SUPPRESSION DIODE INSTALLATION ON M100 & M200 STATUS CARDS

To inform our customers on the installation of the suppression diodes on the M100 & M200 status cards. The addition of these diodes helps to protect the DAC's on the status card from lightning strikes & fluctuations in ac line voltage.

DATE	2.23.95	DESCRIPTION OF CHANGE	C: CORRECTED SCHEMATIC	BY	KL
ECR#					
API ADVANCED POLLUTION INSTRUMENTATION INC. SAN DIEGO, CA					
APPROVALS	DATE	ICTE-15 MODIFICATION			
DRAWN		00246 STATUS BOARD			
CHECKED		SIZE	DRAWING NO.	01590	REVISION C
APPROVED		SCALE			SHEET 1 OF 1
DID NOT SCALE DRAWING

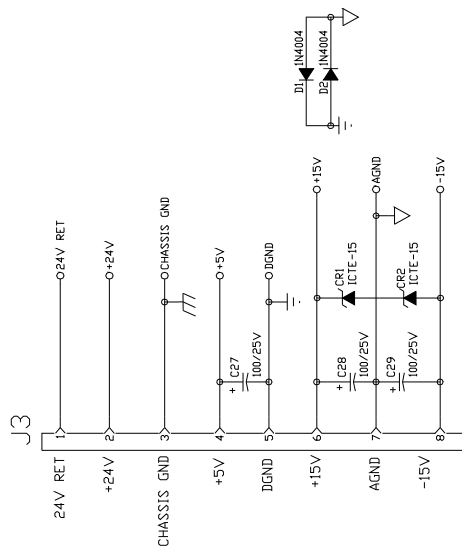
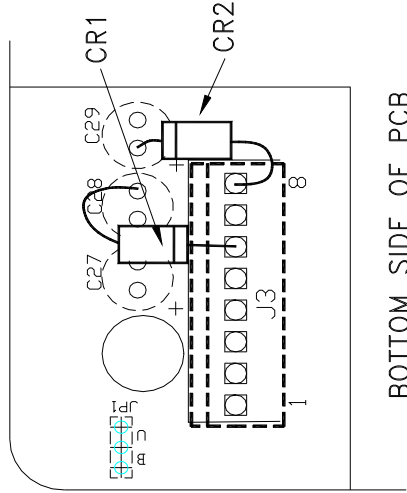
6. Bend the leads of the diodes so that they look like the picture in the attached diagram.
7. Solder the leads of the diodes to the rear of the status card (the side of the status card that faces the rear panel, the hidden side). You will be soldering the leads of the diodes to the connector that the power for the card comes into. The connector is J3. You will notice that J3 is silk screened onto the PC card. Also you will notice that there is a 1 & 8 on the PC card as well, these numbers reference the pin numbers of that connector. You will be soldering the diodes to pins 6, 7 & 8.

8. You will be putting one of the diodes onto one side of the connector & the other diode on the other side of the connector (see the attached

- diagram). Make sure that you have the polarity of the diodes correct, check the line on the diode to make sure that it is correct compared to the print.
9. Once you have the diodes soldered onto the connector push the diode so that it is flush against the PC card as well as practical.
 10. Install the status card in the reverse order of removal.
 11. Apply power to the analyzer
 12. Test the analog output using the analog output test in the DIAG menu.
 13. Return the analyzer to service.

CR1 & CR2 = ICTE-15 STK# DD35
 MOUNT CR1 & CR2 ON BOTTOM SIDE OF PCB
